Environmental Review Team Report

Calvo Country Homes

Coventry, Connecticut

May 1980

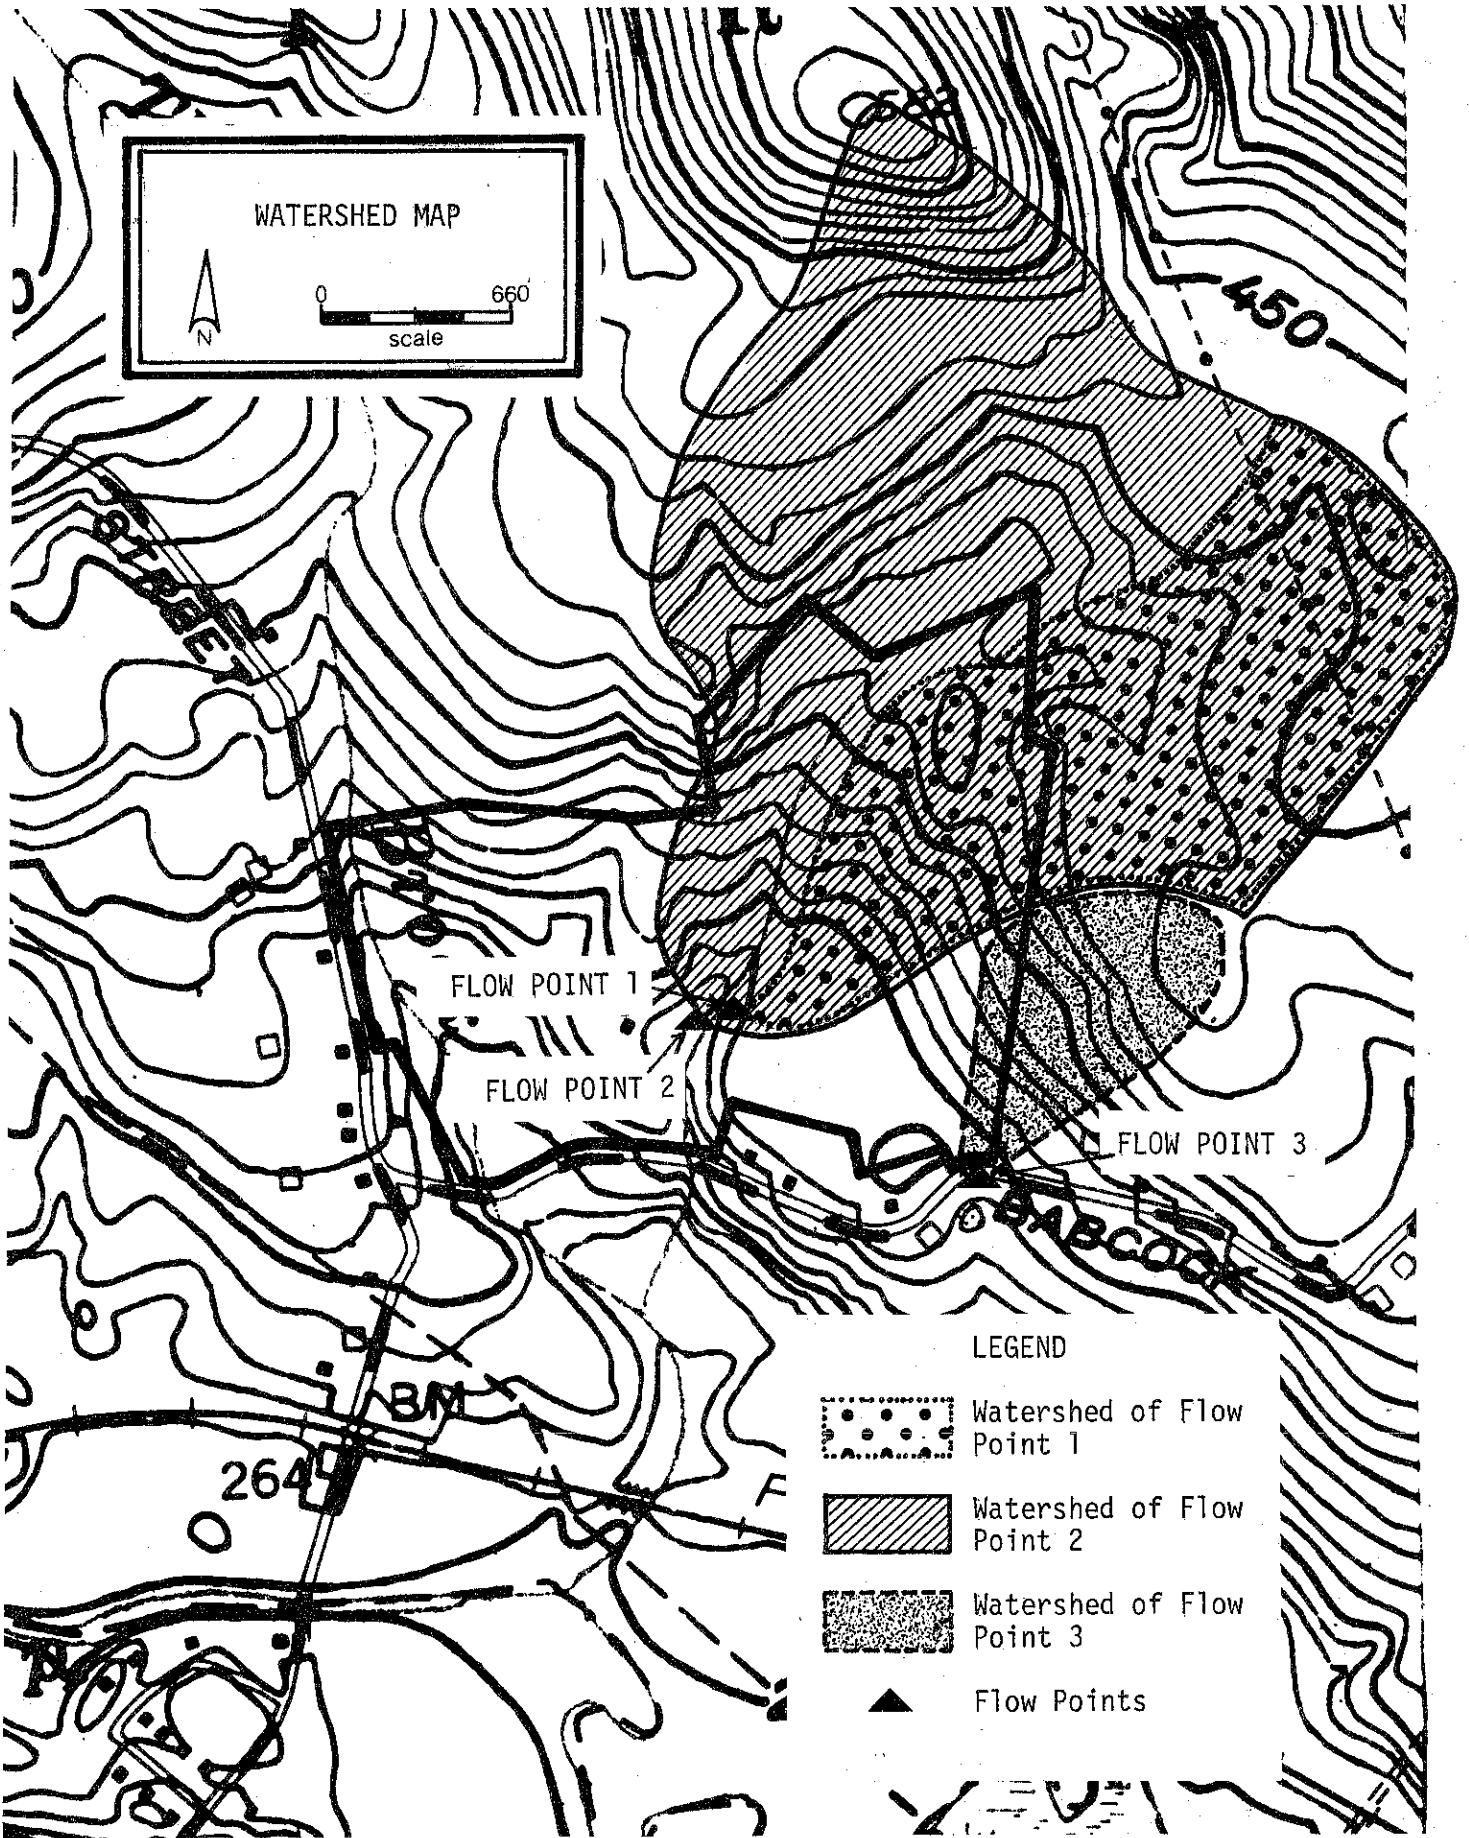
The accompanying watershed map shows the three flow points studied in this report and their respective watersheds. Table 1 lists the estimated peak flows for the three design storms both before and after development as planned. Prediction

As Table 1 shows, the peak flow increases to be expected following development are substantial. These increases further the potential for erosion upstream from the channel improvements, along existing or new channels, and downstream from the Flow Points. Upstream or on-site erosion may add an extra silt and sand load to both the pond on the site and the pond south of Babcock Hill Road near the eastern edge of the site. This potential problem would be more serious for the on-site pond since it receives drainage from approximately 120 acres of land, whereas the pond south of Babcock Hill Road is fed by runoff from only about 20 acres. A modestly-sized sediment basin near the proposed entrance to the site from Babcock Hill Road may alleviate most siltation problems for the off-site pond.

The on-site pond will be affected both by the probable influx of sediment and by the peak flows themselves. The pond had overtopped its driveway-dam just before the team's field review following a storm of less than 10-year magnitude. A decreased capacity from additional sediment and increased flow rates from heavy rainfall will stress the dam and will cause a greater frequency and somewhat higher levels of flooding. Higher flood levels may also be anticipated in the vicinity of the proposed cul-de-sac, which is already planned for an area of seasonally wet soils.

It is beyond the scope of this ERT report to recommend specific drainage measures, but it is clear that drainage is one of the most crucial considerations for a sound development on this site. The landowners should decide what future use they wish to make of their pond and should determine whether it will be feasible to maintain it in view of the potential for greatly increased inflows. Flow-reducing measures of some sort and a strict sediment-and-erosion-control plan are essential. Whether and how to make the proposed channel improvements should be carefully rethought. Legal considerations also may be involved in allowing increased runoff to flow south from the site to the neighboring property and pond.

VEGETATION TYPES

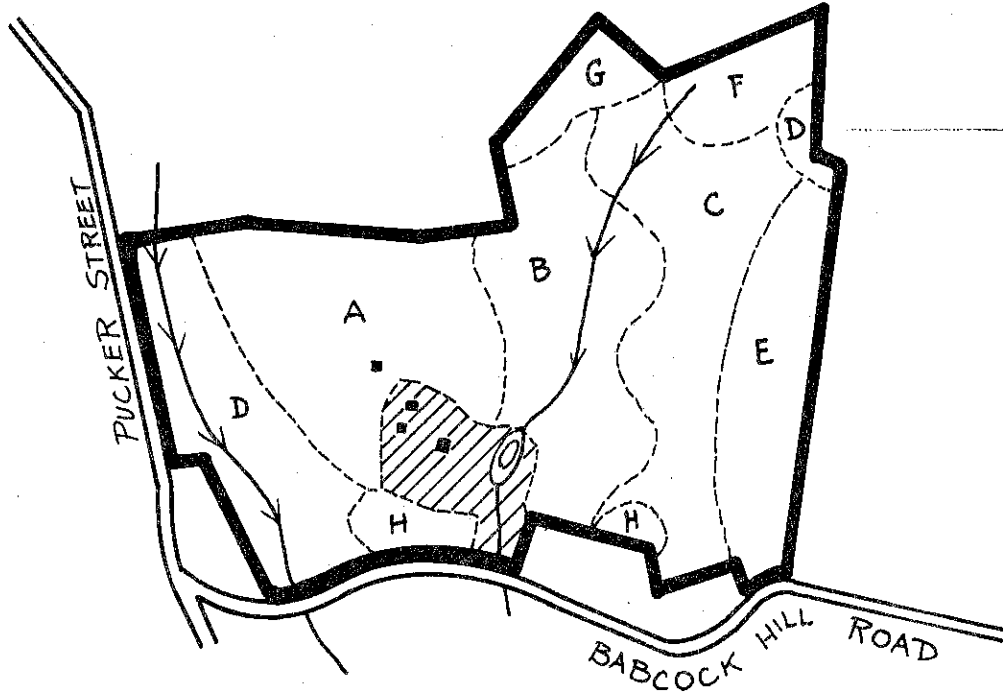
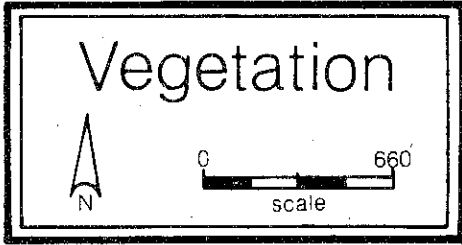
The dense growth of old field juniper, which is presently wide spread in stands A and E (see vegetation type map), precludes other ground cover vegetation in these stands. Under these conditions the establishment of other more desirable

The soils associated with the hardwood swamp area (stand type D) are characterized by a permanently high water table. Vegetation growth is limited to species that are able to tolerate the saturated and poorly aerated nature of these soils. Red maple are able to survive under these conditions, however, they are unstable because their root systems are shallow and their growth rates are restricted. Management of this area for timber production is not economically feasible due to the lack of desirable species, poor growth rates and the severe limitation which the high water table imposes on equipment use.

Windthrow is a potential hazard in the hardwood swamp area (stand type D) and also in the mixed hardwood stands B and C.

The trees in vegetation stand type B, (mixed hardwoods) are declining in health and vigor as a result of their over crowded condition. This stand would benefit by receiving a light fuelwood thinning that would remove between one quarter and one third of the total volume or four to five cords per acre. This thinning should focus on the removal of poor quality trees, damaged trees, and unhealthy trees, along with trees that are directly competing with healthy high quality trees. If subdivision of this tract does occur the high quality sawtimber size trees should be left for their aesthetic and shade value. This thinning will improve the health, vigor and stability of residual trees, over time by reducing competition for space, sunlight and nutrients. If the proposed thinning is agreed upon, a consultant forester should be contacted to mark the trees to be removed.

PROPORTIONAL EXTENT OF SOILS AND THEIR LIMITATIONS FOR CERTAIN LAND USES

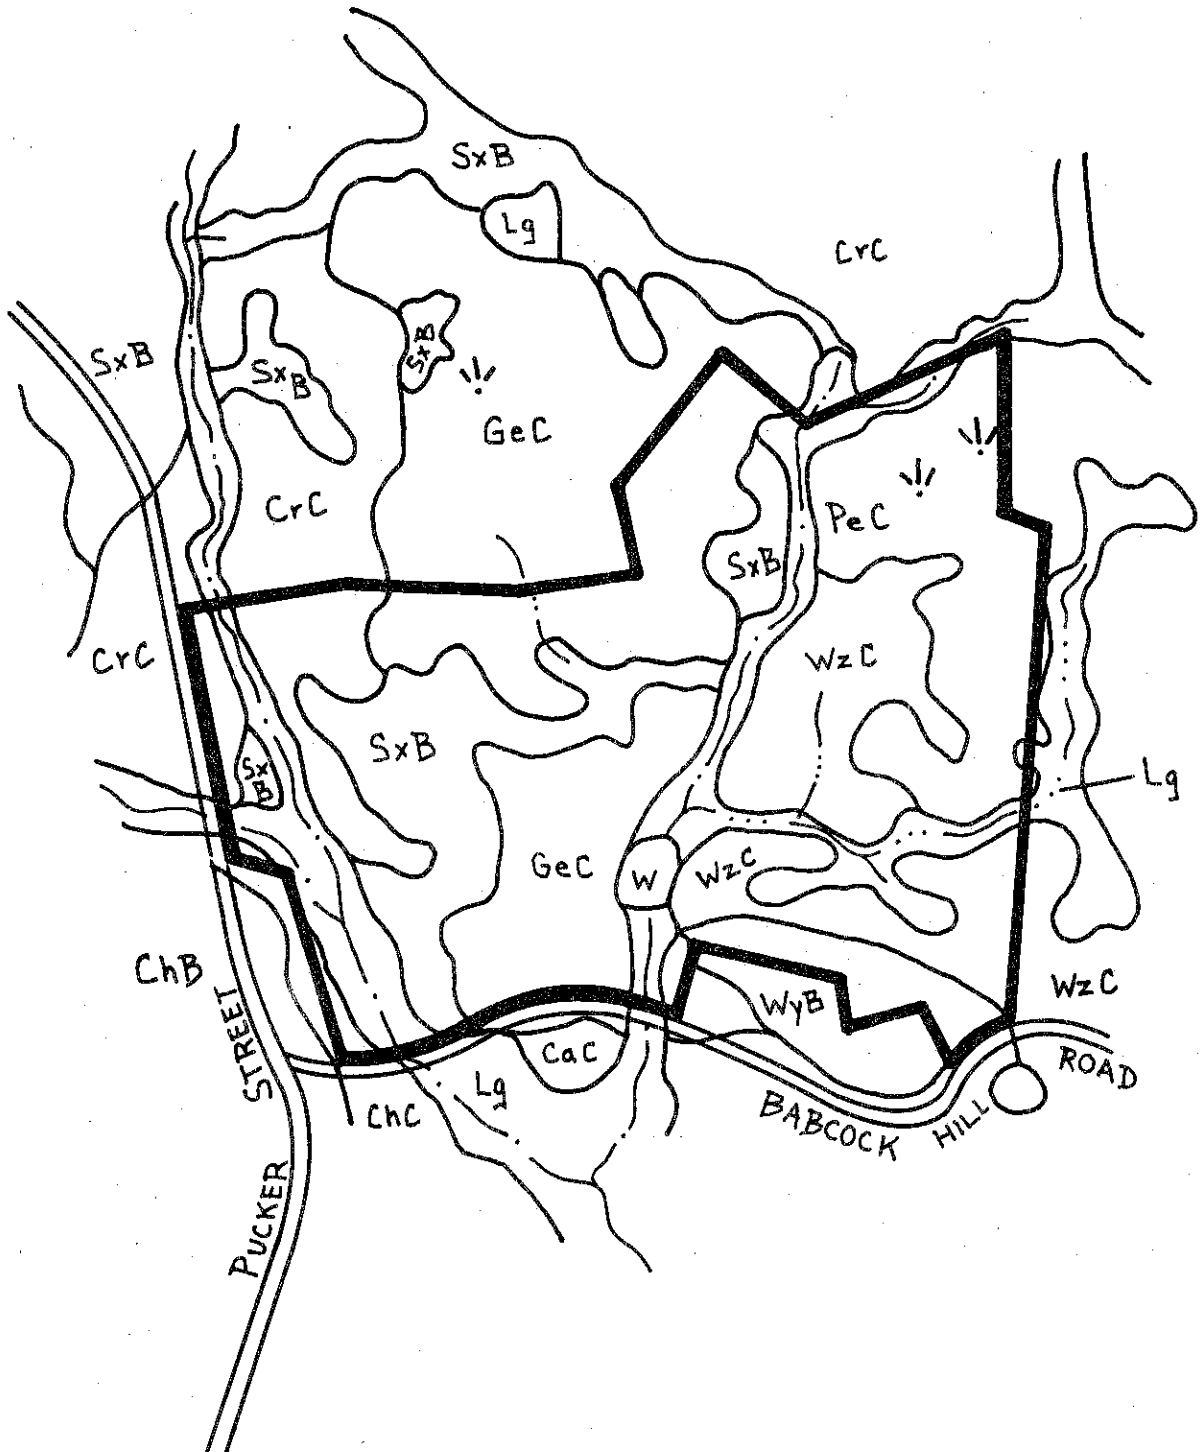
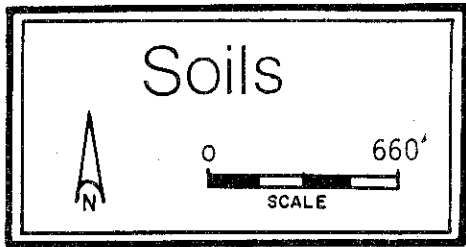
There were areas of wetland soils within the SxB delineation on the western border of the property near Thornton Brook, in the WzC delineation near the center of the property and in the PeC delineation in the northeast corner of the property. These areas were too small to show on the 1320' scale map used for mapping. It appears from the proposed plans, that some of the lots are planned in or near these areas.

Because of the complexity of this area, it is recommended that the developer have the site mapped and flagged by a qualified soil scientist. Soil types and wetland areas can then be accurately shown on the subdivision plan map. Because of scale limitations, the 1"=660' soils map provided with this report should be used only as a guide for developing a more detailed soils map. The detailed soils map and interpretive data should provide the developer with a guide for planning the subdivision proposal.

The proposed cul-de-sac and lots appear to be located in a wetland area. The developer should recognize the limitations and adverse environmental effects of construction in these type of soils.
